Richard C. Slade & Associates, LLC  
Hydrology Response  
Final version (Not Marked "Draft") - No  
Changes Have Been Made To The  
Analysis

MEMORANDUM

Re: Response to Public Comments  
Proposed Mountain Peak Winery (Application #P13-00320)  
3265 Soda Canyon Road, Napa County, California

**FIGURE C**  
**RESULTS OF CURVE-FITTING ANALYSIS**

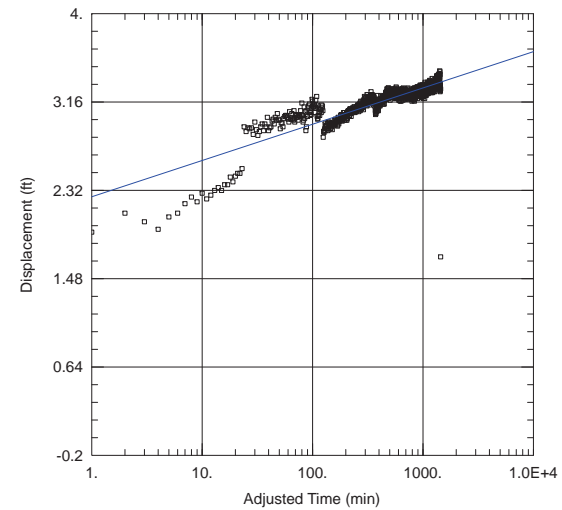
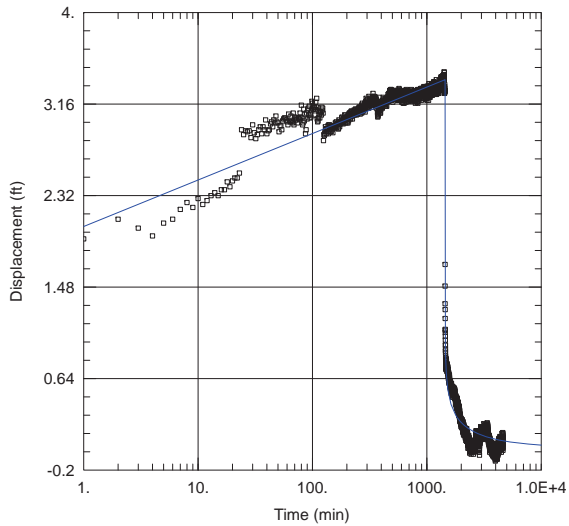
Water level drawdown data and recovery data collected during the Project pumping test were input into the software program AQTESOLV Professional (version 4.5). Numerous analytical solutions were utilized to determine transmissivity values using an automatic curve fitting procedure. **Figure C** – “Results of Curve-Fitting Analysis” shows two of the

numerous solutions analyzed. Based on those data, a transmissivity of 4,100 ft<sup>2</sup>/day (30,668 gpd/ft) is considered to be representative for the fractured rock aquifers in the vicinity of the Project property.

## FIGURE D THEORETICAL WATER LEVEL DRAWDOWN CALCULATIONS

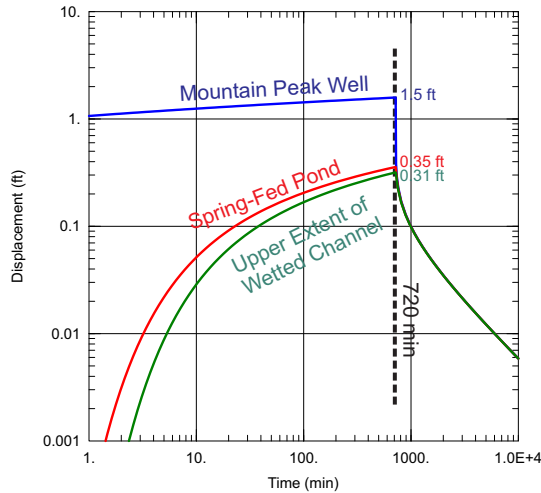
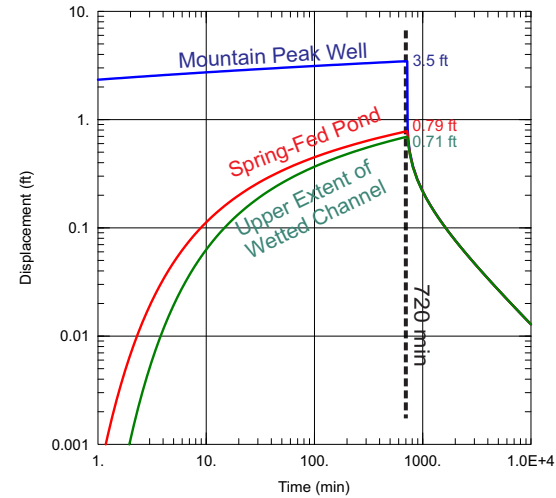
6. "Water Availability Analysis does not evaluate project impacts to groundwater/surface water interaction that sustain adjacent creek flow"

Kamman 2016 reports that an offsite "spring/seep" is located on private property north of the Project site, as shown on **Figure B**. This location is reportedly based on the "upstream limit of the wetted channel" observed by Kamman and described in their 2016 letter, and is Kamman's purported basis for a WAA Tier 3 analysis. Kamman 2016 states (underlining added by RCS), *"For the purposes of this procedure, surface waters are defined to include only those surface waters known or likely to support special status species or surface waters with an associated water right; however, as with all of the procedures in this WAA, there may be unique circumstances that require additional site specific analysis to adequately evaluate a project's potential impacts on surface water bodies."*

Using the assumptions described above, Figure D “Theoretical Water Level Drawdown Calculations,” has been prepared to show the calculated water level drawdown values at the “spring-fed pond” and the “upper extent of wetted channel” following 720 minutes of continuous pumping at the for two different pumping rates: at a constant rate of 21 gpm and at a constant rate of 46 gpm. A summary of the results of the AQTESOLV software calculations are as presented in the following Table:

These theoretical drawdown values (i.e., theoretical water level interference values) at both the “spring-fed pond” location and the “upper extent of wetted creek” location, respectively, are less than 0.5 ft; such small water level changes while pumping the Project well are very likely immeasurable, due to natural fluctuations in the flow of springs/seeps. These values are also far less than the “Default Well Interference Criteria” shown on Table F-1 of the May 12, 2015 Napa County WAA Guidelines. In addition, in our long-term experience in the field monitoring of water levels in wells during actual pumping tests, RCS has typically found that theoretically-calculated values are virtually always greater than the actual field-monitored values.

<b>RICHARD C. SLADE &amp; ASSOCIATES LLC</b> Consulting Groundwater Geologists	
Project No: 827-161003	<b>Figure E Watershed Boundaries</b>
Date: November 2015	
Author: ASH	
14051 Barbara Blvd., Ste. 500, Sherman Oaks, CA 91403 Phone: (818) 506-0416 Fax: (818) 506-1342

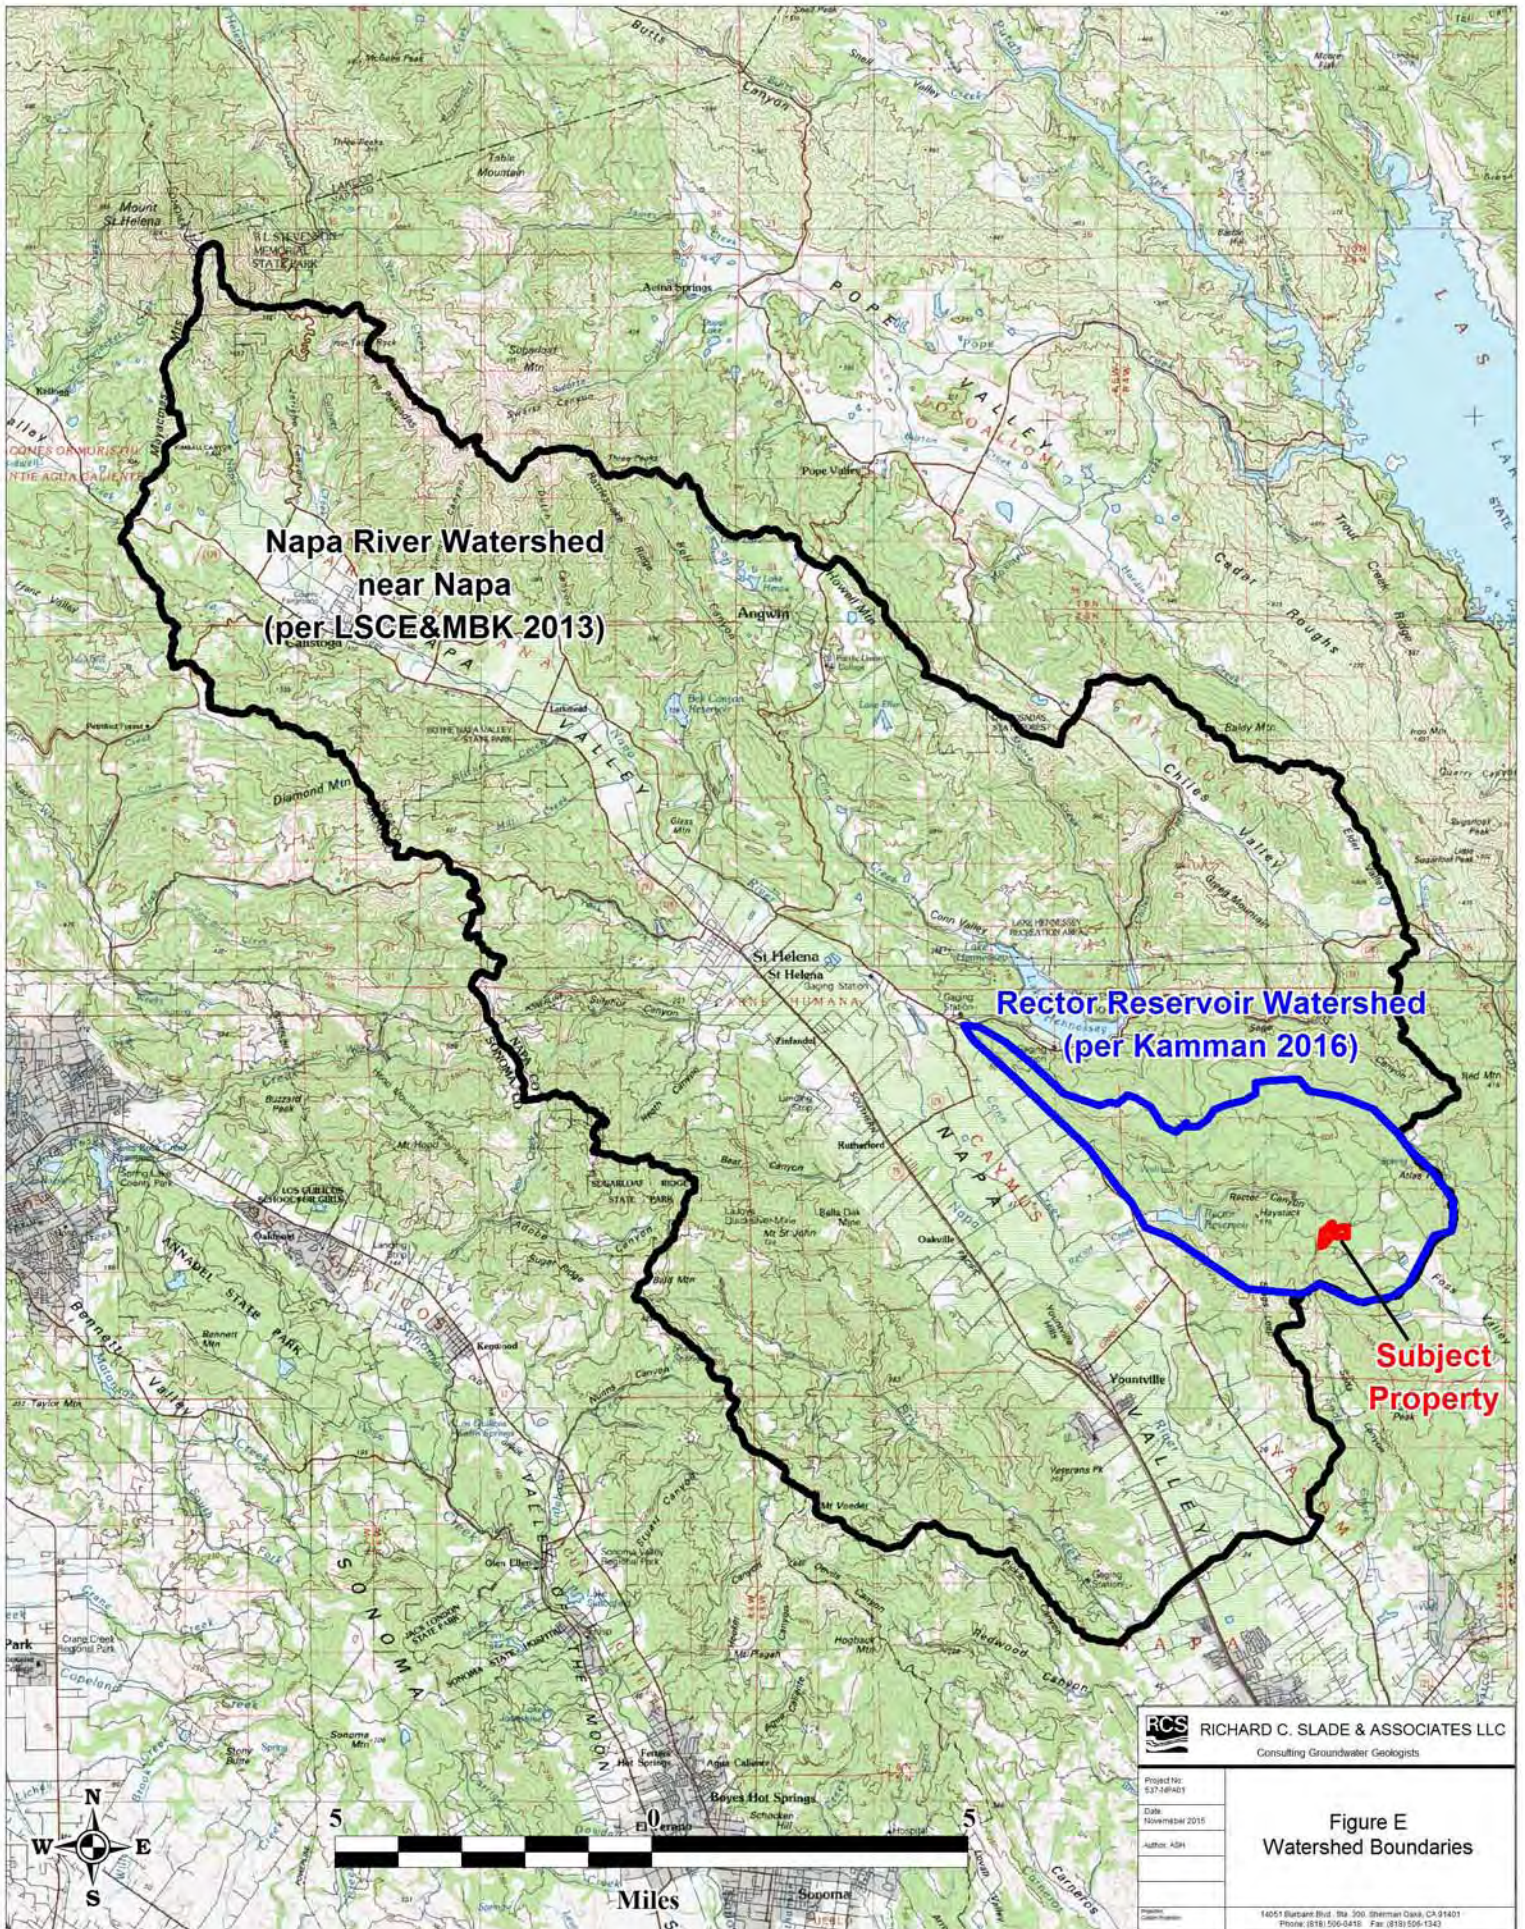
Kamman 2016 then suggests that the Milliken Creek Watershed rainfall deep percolation percentage of 8% (as listed in LSCE&MBK, 2013) is a possible appropriate recharge rate for the Project property, due to the proximity of the Milliken Creek watershed to the watershed in which the Project property lies, and that the fact that the Milliken Creek watershed is comprised primarily of rocks of the Sonoma Volcanics, as is the watershed in which with Project property lies. However, Kamman 2016 fails to mention that in the LSCE&MBK 2013 report, the Conn Creek Watershed, just north of the Project property was shown by LSCE&MBK 2013 to have a rainfall deep percolation percentage of 21%. That watershed is comprised of both water-bearing rocks of the Sonoma Volcanics, and older, highly consolidated, generally poor water-bearing rocks of the Great Valley Complex and/or the Franciscan Complex.

A watershed-wide assessment can also be made using the BCM data. Such use is consistent with the recommended “watershed-scale evaluations” described in the “limitations of use” section of the document that is distributed with the BCM dataset. Figure E, “Watershed Boundaries” illustrates two watershed boundaries: the “Napa Watershed near Napa” boundary adapted from LSCE&MBK 2013; and the approximate “Rector Reservoir Watershed” from Figure 2 of Kamman 2016. The Project property lies within the latter watershed. Using the same zonal statics calculations on those watershed polygons with GIS software in conjunction with the BCM gridded data sets, the same calculation was performed as was described above, and the results of those calculations are presented in Table C “Watershed-scale Calculated Rainfall Recharge Percentage Using BCM Dataset”.

As shown in Table C, the watershed-scale calculations using the BCM data suggest that the calculated rainfall recharge percentage for the “Rector Reservoir Watershed” (proposed by Kamman 2016) is roughly 93% of the calculated rainfall recharge percentage for the “Napa River Watershed Near Napa” (this is calculated as  $28\% \div 30\% = 93\%$ ). This same ratio between the larger “Napa River Watershed Near Napa” watershed and the smaller “Rector Reservoir Watershed” can be applied to the actual calculated data presented in the LSCE&MBK 2013 report. In Table 8-9 of that LSCE&MBK 2013 report, the rainfall deep percolation percentage for the “Napa River Watershed Near Napa” was estimated to be 17%. Taking 93% of the LSCE&MBK-reported percentage (17%) yields a deep percolation percentage of 15.8% for the “Rector Reservoir Watershed” in which the Project property is located. This value is also higher than the 14% deep percolation presented in the RCS 2015 Memorandum.
